Technical product information

Topic	V8 Kovomo - Engine MIL light on - DTC 'P04F000: EVAP system high pressure purge line performance' evident
Market area	Australia E04 Bentley rest Asia and Australia (6E04),China 723 Volkswagen (Anhui) Automotive CO (6723),China 796 VW Import Comp. Ltd (Vico), Beijing (6796),Germany E02 Bentley rest Europe (6E02),Japan E03 Bentley Japan (6E03),Korea, (South) E08 Bentley South Korea (6E08),United Arab Emirates E06 Bentley Middle East and Africa (6E06),United Kingdom E01 Bentley UK (6E01),United States E05 Bentley USA and rest America (6E05)
Brand	Bentley
Transaction No.	2065148/4
Level	EH
Status	Approval
Release date

V8 Kovomo - Engine MIL light on - DTC 'P04F000: EVAP system high pressure purge line performance' evident

Figure 1

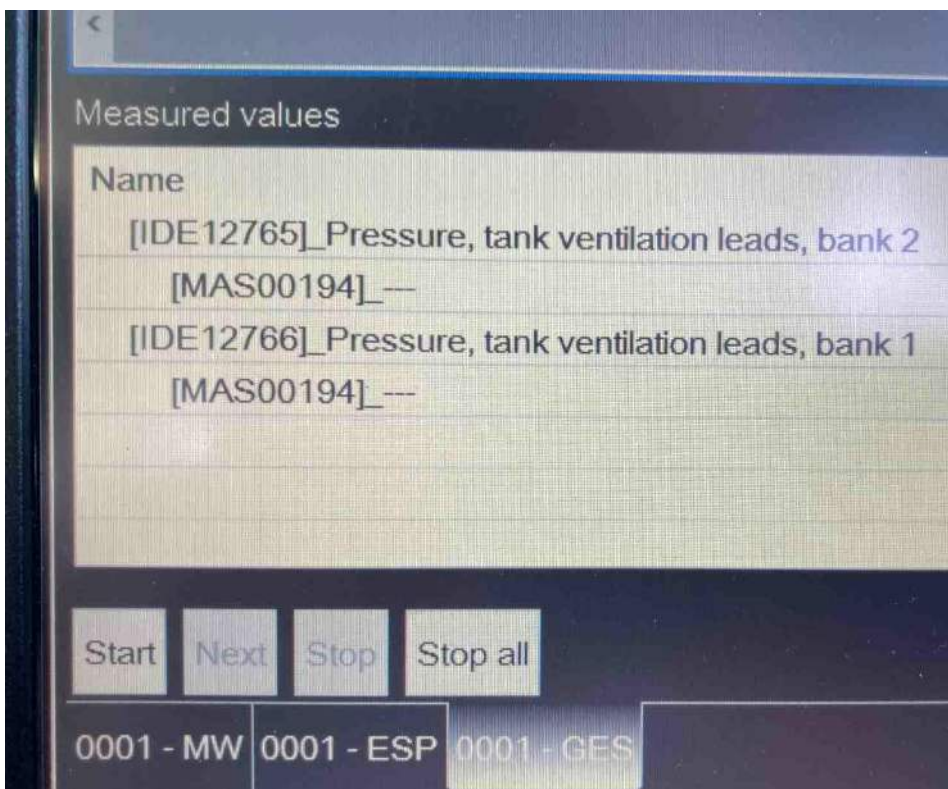
Referring to Figure 1:

IDE12765 (When monitored) fluctuates from the static value found (Ignition on/Engine Off)

IDE12766 (When monitored) DOES NOT fluctuate from the static value found (Ignition on/Engine Off)

Figure 2

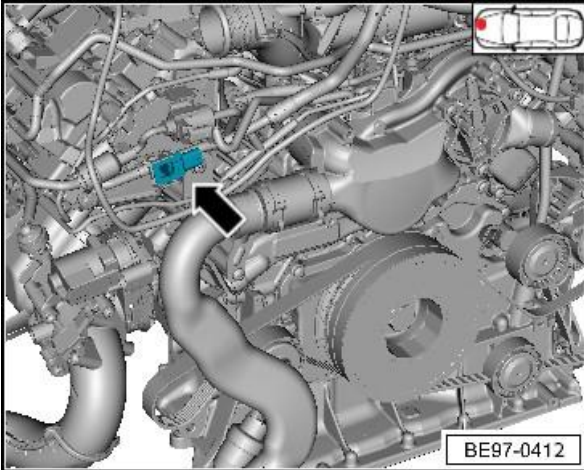
- Referring to Figure 2 - Locate the Pressure sensor connector (T3dd) for the activated charcoal filter system (G804)

- Disconnect T3dd
- Disconnect T56aj from the Engine control unit (J623)
- Referring to the applicable wiring diagram within in Elsa pro - Conduct a wiring integrity check

From T3dd (PIN's 1 and 2) - To Connector T56aj (PIN's 1 and 5)

Figure 3

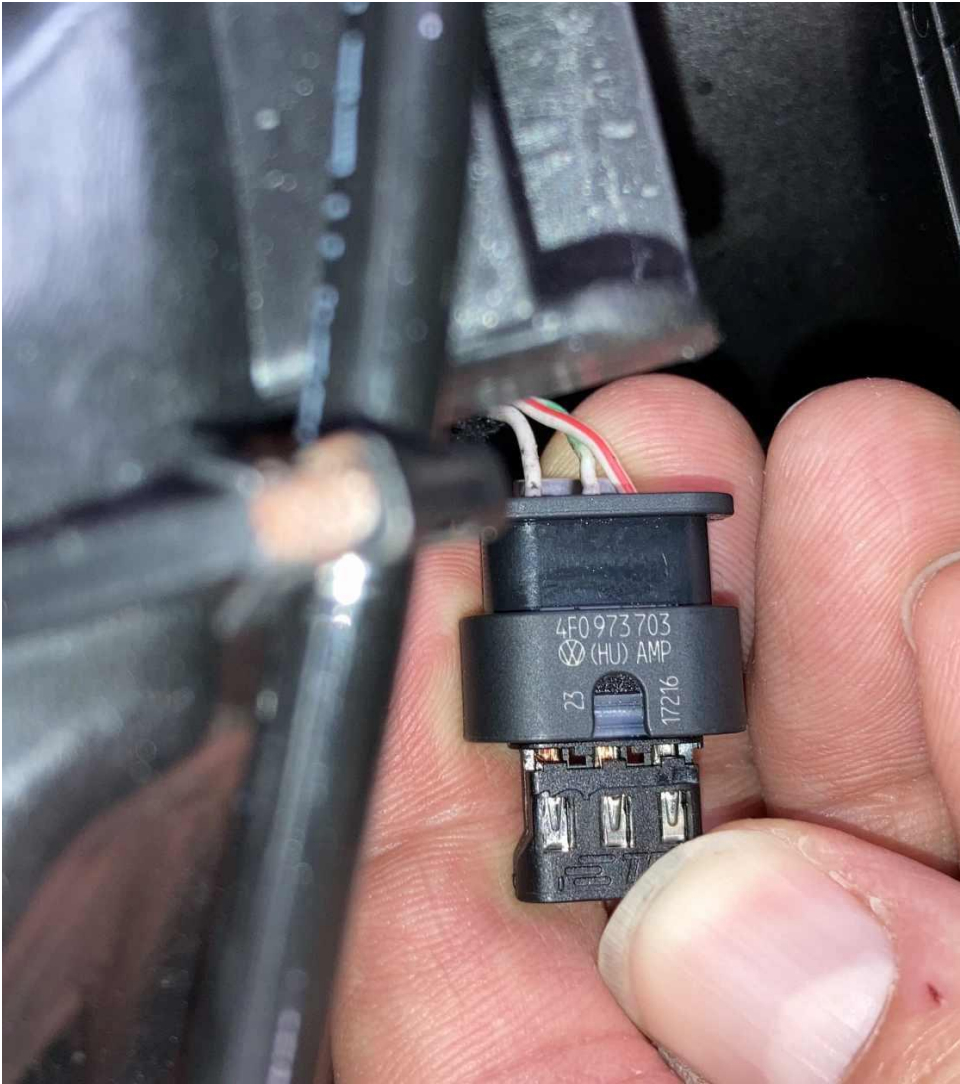
2) Referring to Figure 3 and the attached PDF instructions - De-pin/Remove PIN's 1 and 2 from connector T3dd

TIP: As both wires are white, the green line which can be seen on the central white wire was applied to aid the operative when swapping the PIN's to the correct locations

3) Install PIN 2 into PIN 1

4) Install PIN 1 into PIN 2

5) Conduct a wiring integrity check from T3dd (PIN's 1 and 2) - To Connector T56aj (PIN's 1 and 5)
